## Bayside Planning Panel

Item No	6.5
Application Type	Development Application
Application Number	DA-2016/86/C
Lodgement Date	12 January 2018
Property	<b>15-17 Gertrude Street, Wolli Creek</b>
Owner	MGC Wealth Pty Ltd
Applicant	MGC Wealth Pty Ltd
Proposal	Section 96(2) Application - Modifications comprising the reconfiguration of level 8 to create a dual key apartment and alterations to rooftop communal open space area.
No. of Submissions	Three (3)
Cost of Development	\$30,000.00
Report by	Fiona Prodromou – Senior Assessment Planner

## Planning Assessment Report

<b>Application Number:</b>	DA-2016/86/C
<b>Date of Receipt:</b>	12 January 2018
<b>Property:</b>	15 - 17 Gertrude Street, WOLLI CREEK
<b>Owner:</b>	MGC Wealth Pty Ltd
<b>Applicant:</b>	MGC Wealth Pty Ltd
<b>Proposal:</b>	Section 96(2) Application - Modifications comprising the reconfiguration of level 8 to create a dual key apartment and alterations to rooftop communal open space area.
<b>Recommendation:</b>	Approved
<b>No. of submissions:</b>	Three (3)
<b>Author:</b>	Fiona Prodromou
<b>Date of Report:</b>	12 April 2018

As Approved

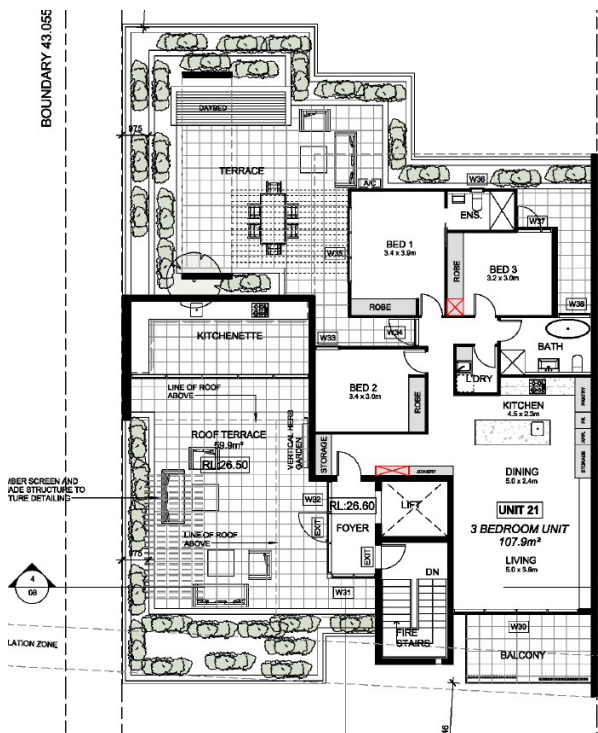
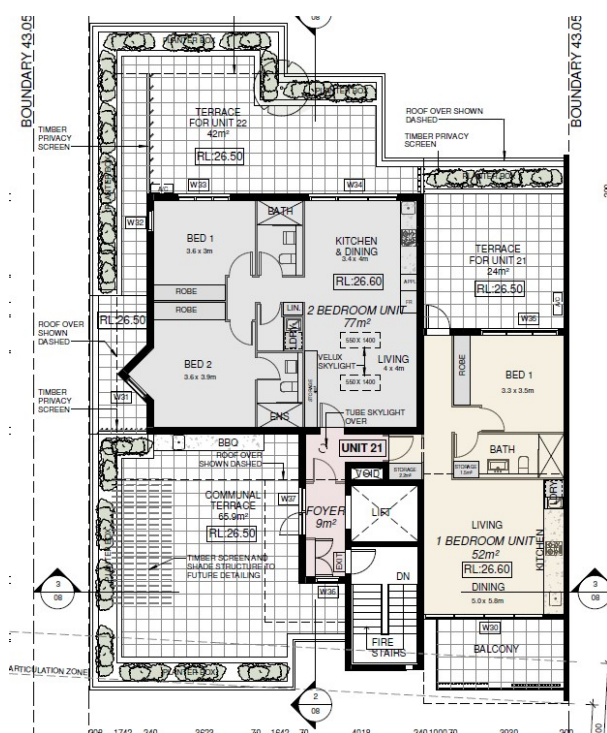
The proposal as modified seeks to alter the layout of previously approved level 8 as follows:

a) Reconfiguration to level 8 communal open space area, including a reduction in width of planter box area along the northern edge to increase useable communal areas from 59.9sq/m to 65.9sq/m.

b) Alteration to level 8 building footprint and creation of 1 x dual key apartment in lieu of previously approved 3 bedroom unit. The dual key apartment is accessed via a single foyer and can be utilised as 1 x 2 bed & 1 x 1 bed dwelling. Associated balcony spaces are provided to this dwelling, along with velux roof windows maximising solar access.

2 Level 8 - Proposed  
1 : 100

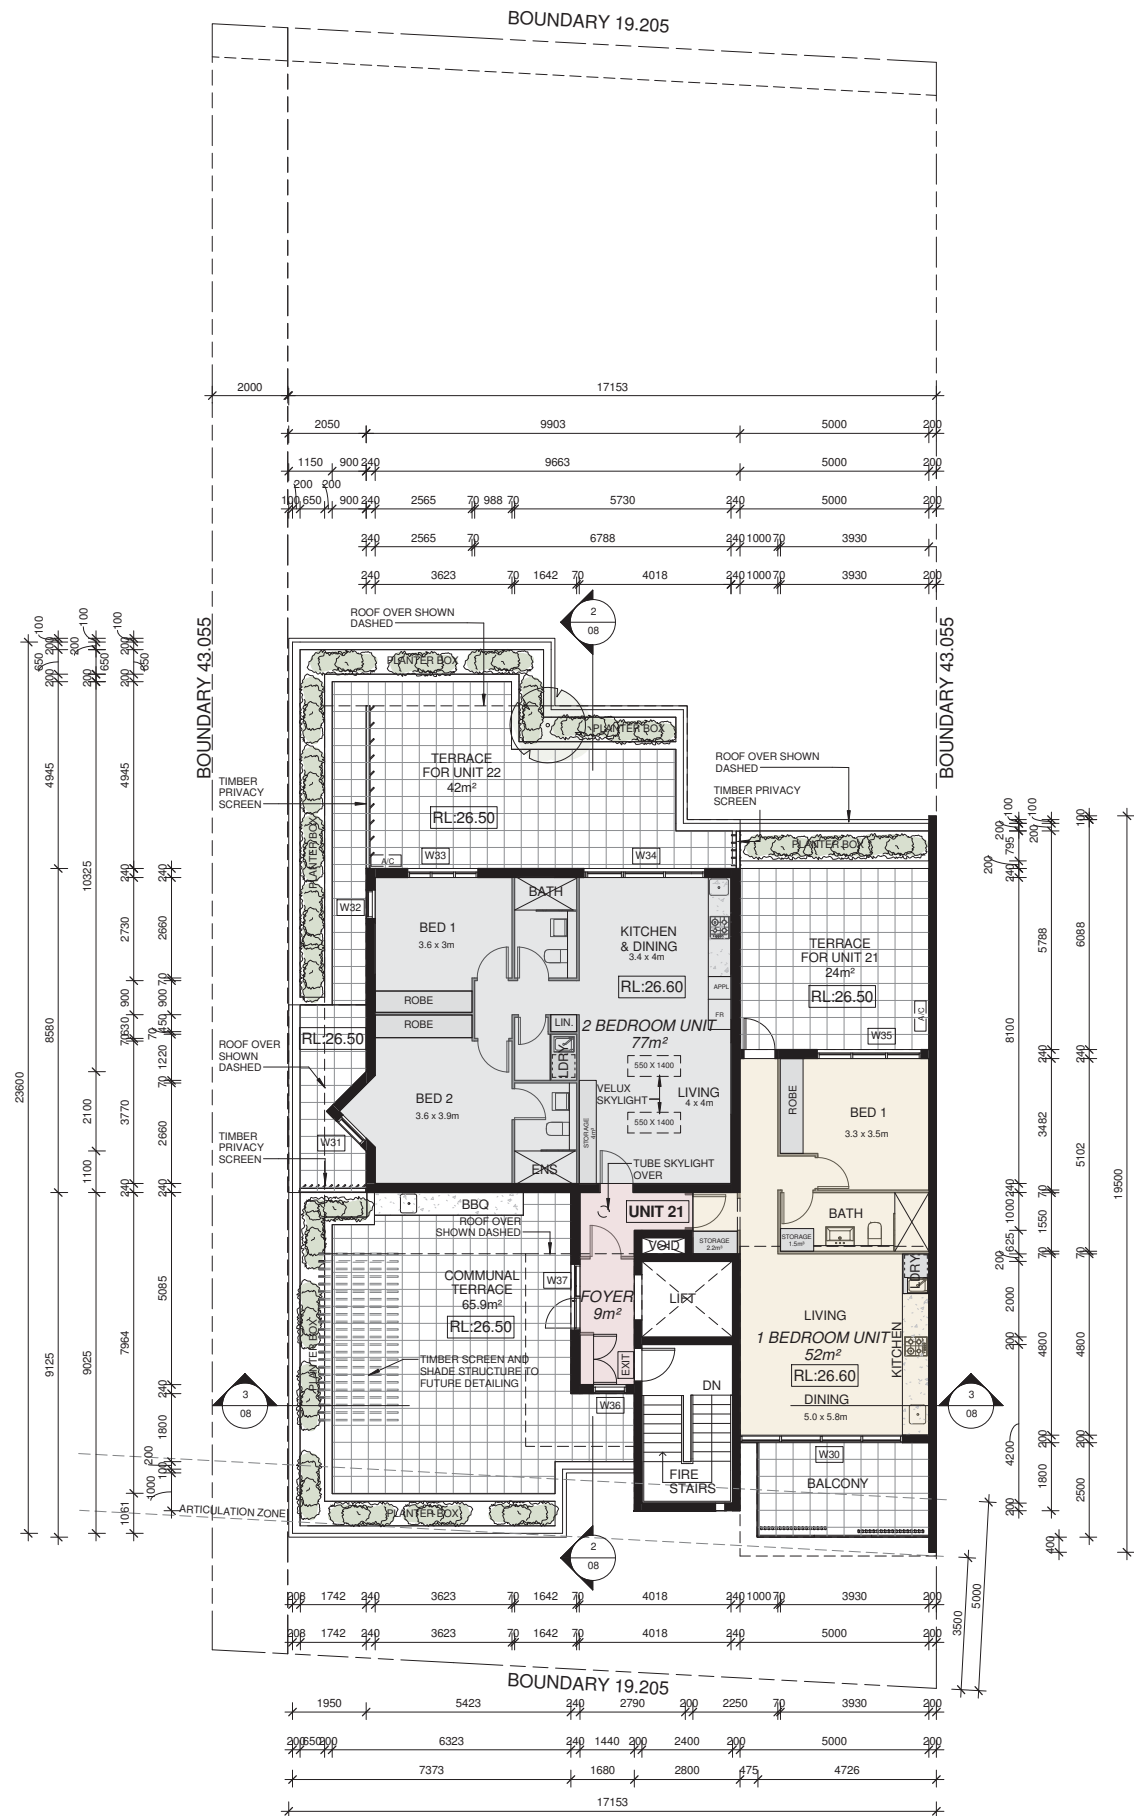
Comments: The proposed modifications alter the top floor of the development, reconfiguring the layout and providing an additional residential dwelling. The proposal however remains as a residential flat building development. As such it is considered substantially the same development.

The proposal as modified seeks to reconfigure the top floor of the development, resulting in a slight variation to the gross floor area and FSR proposed on site. A total gross floor area of 1842.5sq/m and FSR of 2.207:1 is proposed as part of this application. This equates to 6.4sq/m of surplus gross floor area, being a 0.34% variation to the standard.
